# Access Compliance Report

## Public Rights-of-Way

Intersection ID: 20578	Main Street: EMERALD_MEADOW_LN	Cross Street: ENGLISH_SADDLE_LN	Location: W
ADA ID: D4E04061FC92	Ramp Type: PerpDiag	Initial Pass/Fail: Fail	Overall Compliance: No
Severity Score: 22.5			
Codes/Mitigation Info/Possible Solution		Field Measurements/Component Compliance

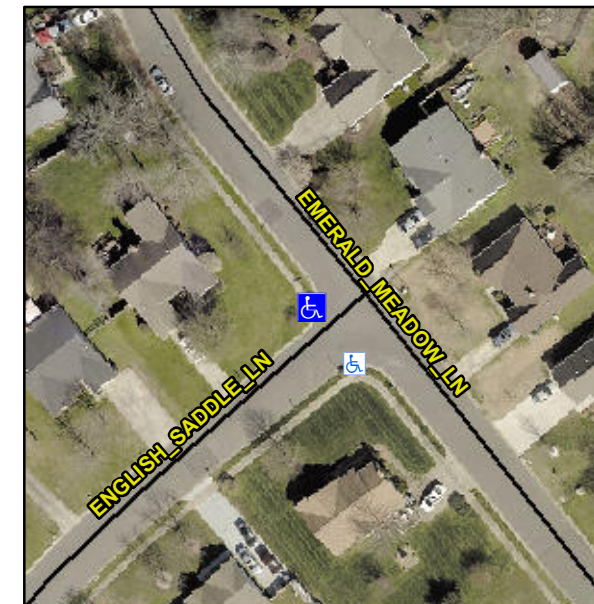
**Remove & Replace Curb Ramp With Two New Directional Ramps or Equivalent.**

**R304.5.1, R304.2.2, R304.5.3**

Compliance	Description	Data	Compliance	Description	Data
N/A	Ramp Length (in)	48.0	No	Ramp Slope (%)	8.5
No	Ramp Width (in)	39.0	No	Ramp XSlope (%)	2.8
N/A	Flare Type LT	N/A	N/A	Flare Type RT	N/A
N/A	Flare Slope LT (%)	N/A	N/A	Flare Slope RT (%)	N/A
N/A	Flare Traversable LT?	N/A	N/A	Flare Traversable RT?	N/A
N/A	Landing Length (in)	N/A	N/A	DWS Provided?	N/A
N/A	Landing Width (in)	N/A	N/A	DWS Contrast?	N/A
N/A	Landing Slope (%)	N/A	N/A	DWS Length (in)	N/A
N/A	Landing X Slope (%)	N/A	N/A	DWS Full Width?	N/A
N/A	Landing Curb? (Y/N)	N/A	N/A	DWS Offset (in)	N/A
N/A	Shared Landing?	N/A			
N/A	Gutter Ponding?	N/A	N/A	Gutter Slope (%)	N/A
N/A	Gutter Lip Ht (in)	N/A	N/A	Gutter X Slope (%)	N/A
N/A	Painted X Walk1?	No	N/A	Painted X Walk2?	No
	X Walk 1 Direction	To SE		X Walk 2 Direction	To NE
N/A	X Walk 1 Width (in)	N/A	N/A	X Walk 2 Width (in)	N/A
	X Walk 1 Slope (%)	1.9		X Walk 2 Slope (%)	2.4
	X Walk 1 X Slope (%)	2.2		X Walk 2 X Slope (%)	1.3
